PROPOSED REFINEMENT TO MASTERPLAN 2030

DRAFT SYDNEY OLYMPIC PARK MASTER PLAN 2030 (2016 REVIEW) AND
DRAFT AMENDMENTS TO SEPP (STATE SIGNIFICANT PRECINCTS) 2005

November 2016

Diagram 12

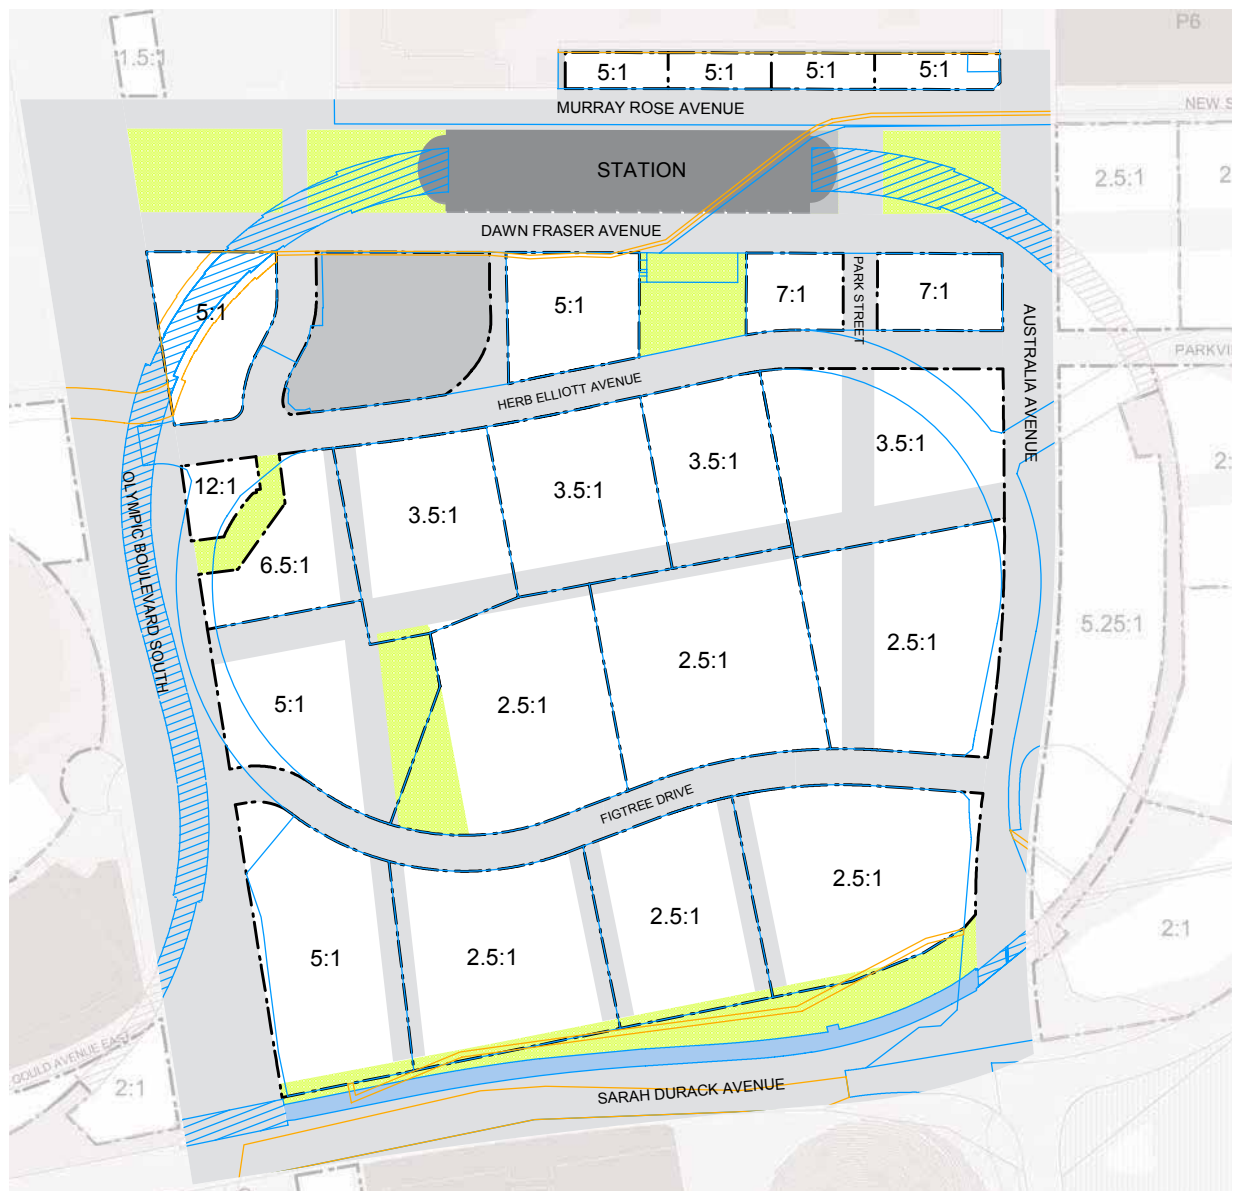
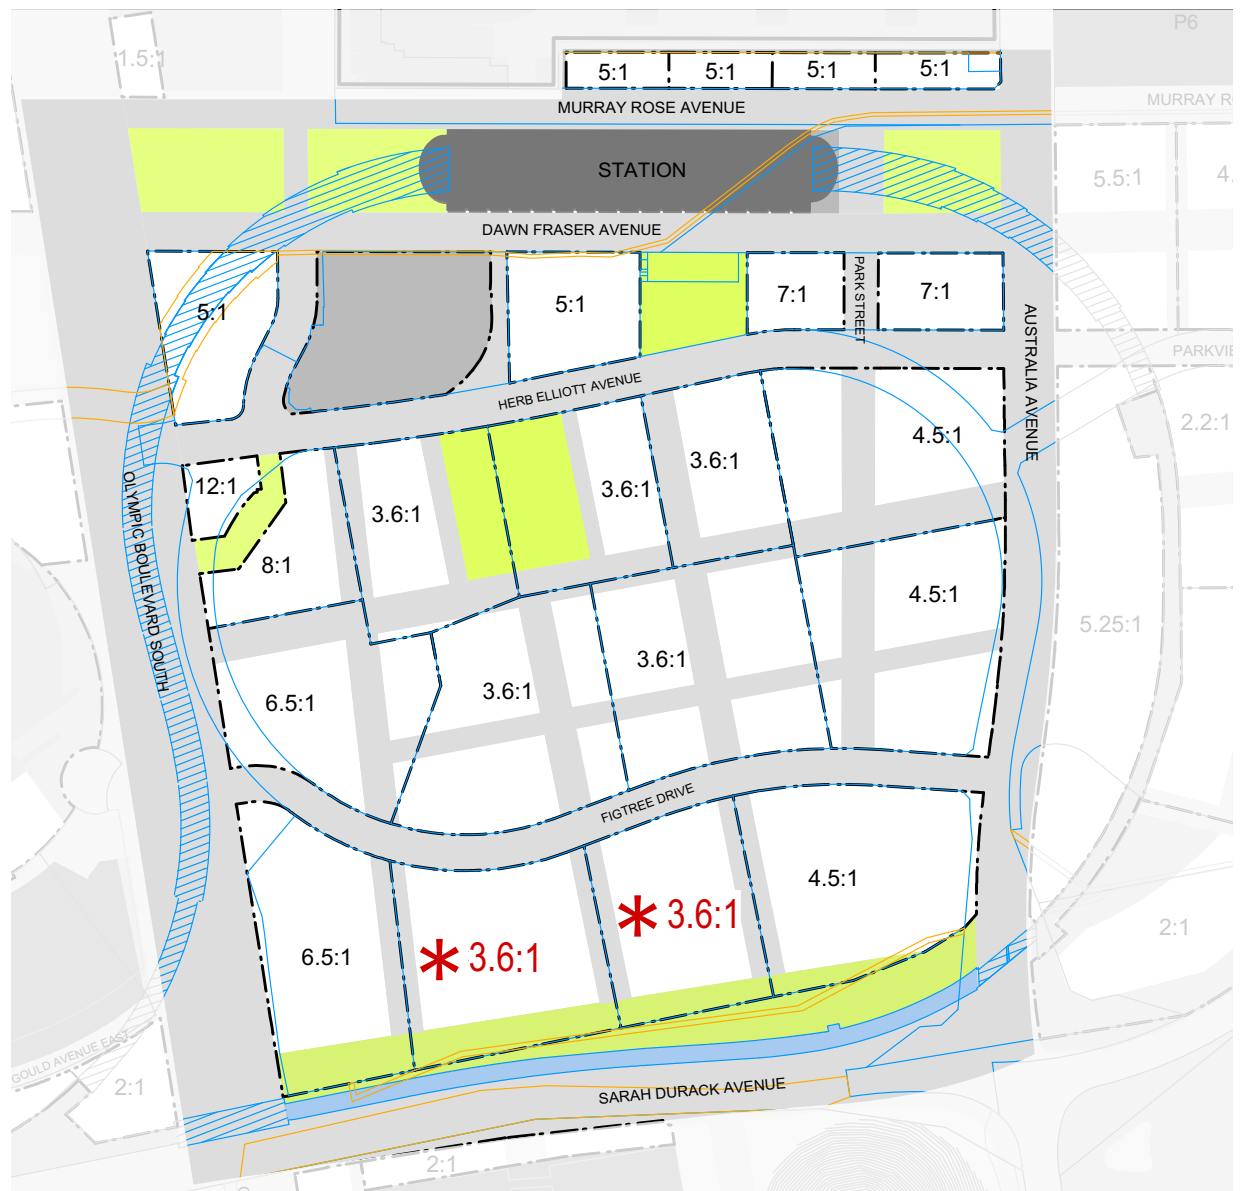
Overall the exhibited FSR and split building height of both Site 51 and Site 52 would restrict flexibility to achieve design excellence and result in poorer design and amenity outcomes. In light of the above, it is our view that the following amendments, should be made to the Master Plan and SEPP controls as exhibited:

An FSR control of 3.6:1 should be implemented at Site 51. This would continue the density controls from the central section of the precinct, facilitating better and earlier outcomes whilst not undermining the massing or development principles of the precinct. This approach would also accord with the overall strategy within the Master Plan.

Diagram 14

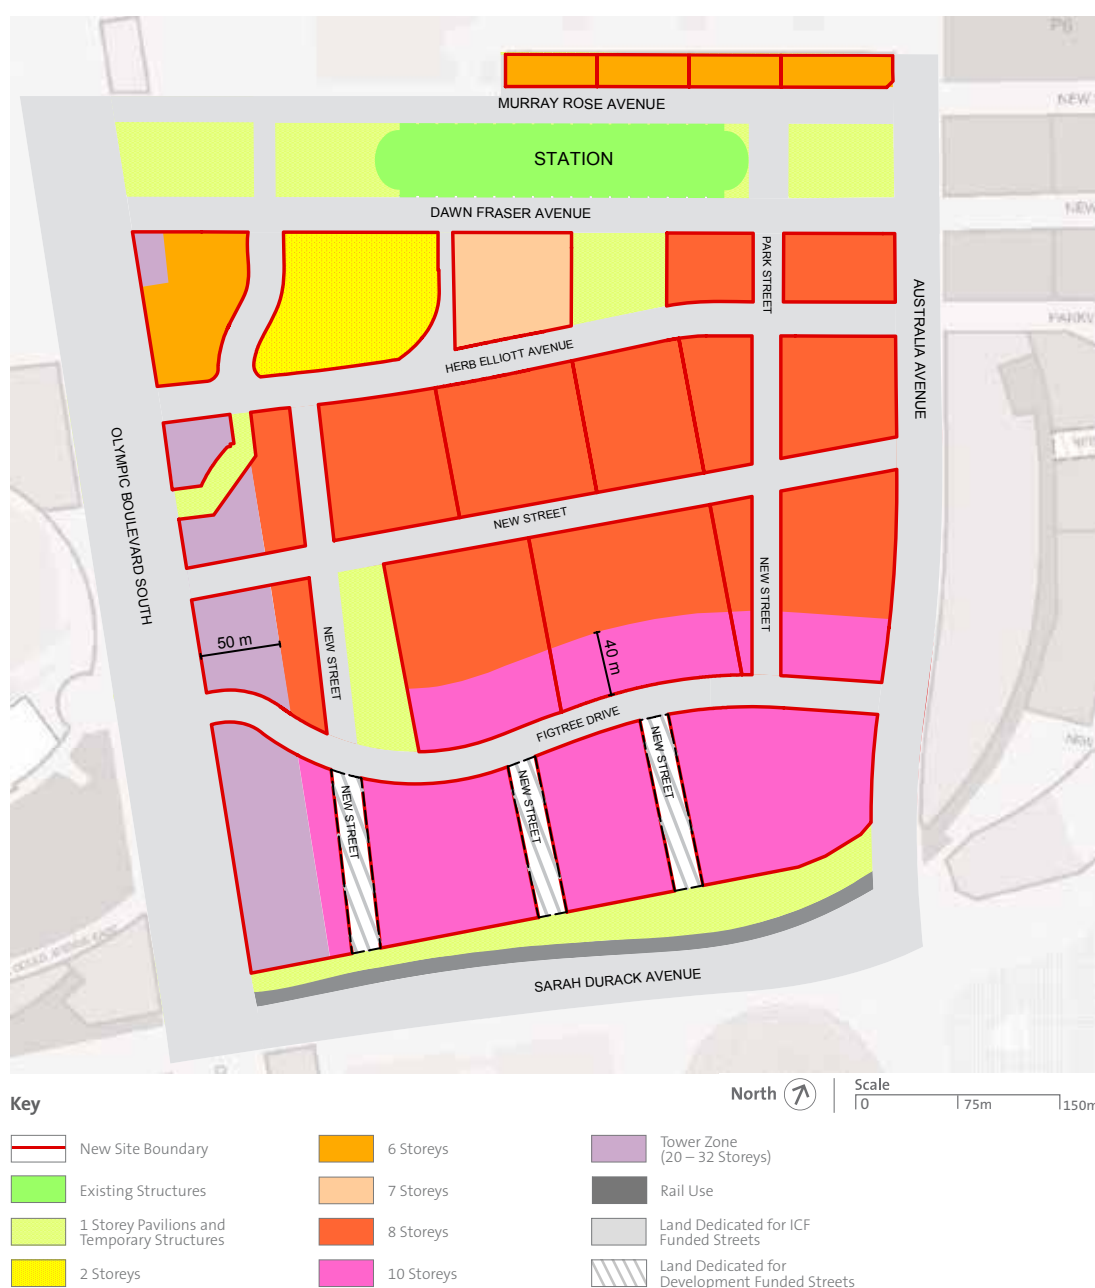
An overall limit of 74 m (as currently already suggested) should be extended across the whole Site. This would allow a greater flexibility with the design of buildings on site, to take advantage of the opportunities arising from the location of the new pedestrian bridge and the high amenity levels which are available. It would also facilitate a more appropriate design and provide a better outcome for massing, shadowing and better architectural outcomes overall.

We suggest that the height of buildings should be expressed in metres rather than storeys, in order to provide greater clarity and consistency with planning controls contained within Environmental Planning Instruments. Therefore, this should be expressed as a 74 metre height limit.

Diagram 15

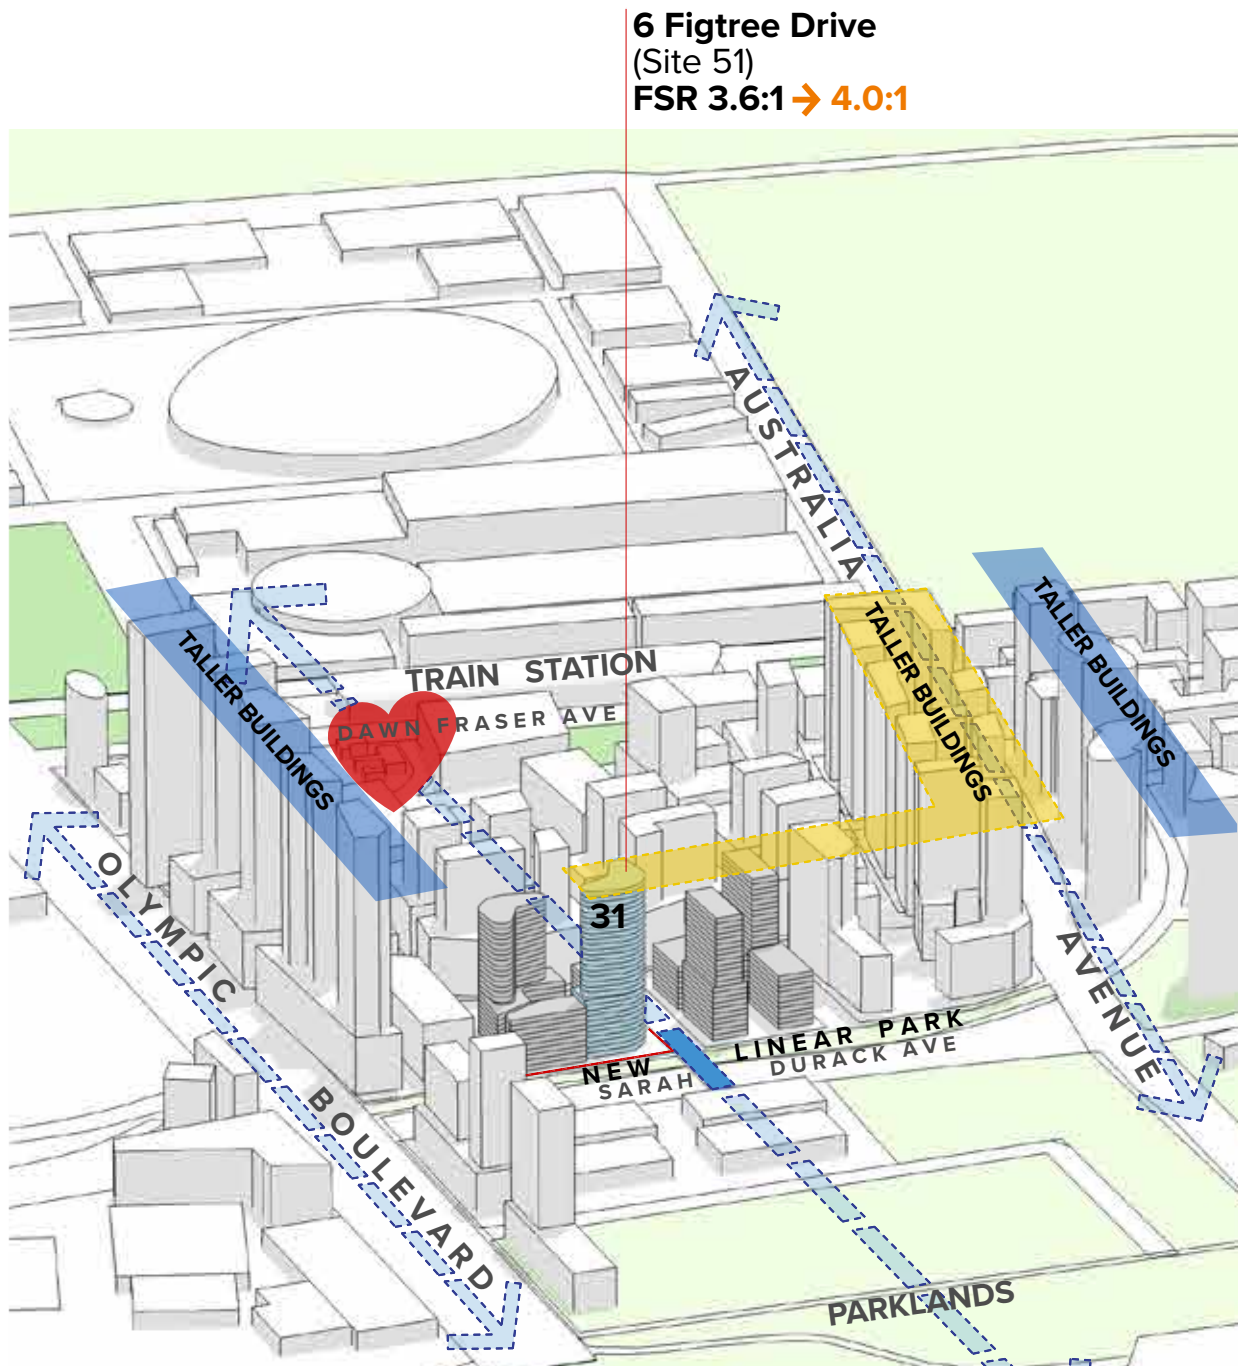
Through this alternate future option proposal, our client believes there is an opportunity to assist SOPA in expediting the delivery of the footbridge. Our suggestion to SOPA is that a future agreement could be reached which facilitates the part funding of the bridge, beyond the existing contribution framework which is in place, derived from development contributions resulting from the development of greater FSR at Site 51. Any additional contributions would need to be reasonable and proportionate to uplift in FSR to 4:1.

Additional height adjacent to new pedestrian bridge reinforces north-south alignment of new connection to the town centre, consistent with planning objectives.

Diagram 18

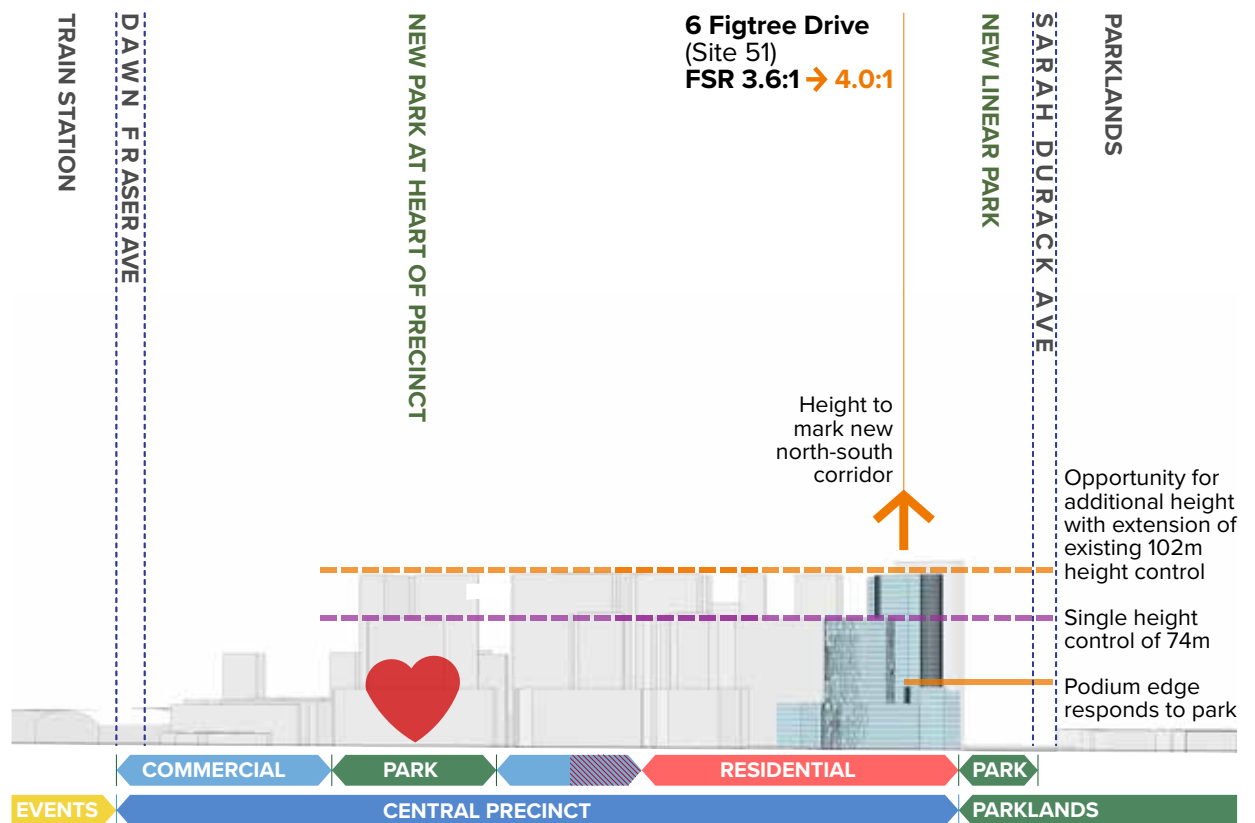
It is clear that with an increased FSR of 4:1, the urban design principles of the precinct would not be undermined, given the heights of the buildings at the southern end of Australia Avenue and Olympic Boulevard (which are 4.5:1 and 6.5:1 respectively). There is a clear benefit in delivering a greater level of new residential development adjacent to this pedestrian bridge, as this would offer future residents a readily accessible connection, which would promote active transport within the Olympic Park. This creation of an active environment is a key objective of the Master Plan.

Additional height adjacent to new pedestrian bridge reinforces north-south alignment of new connection to the town centre, consistent with planning objectives.

It is therefore recommended that further discussions are undertaken with SOPA to determine whether this course of action is supported. Following this, the detail of any arrangement can be worked up and agreed accordingly, which can then be integrated into future Master Plan revisions where appropriate.
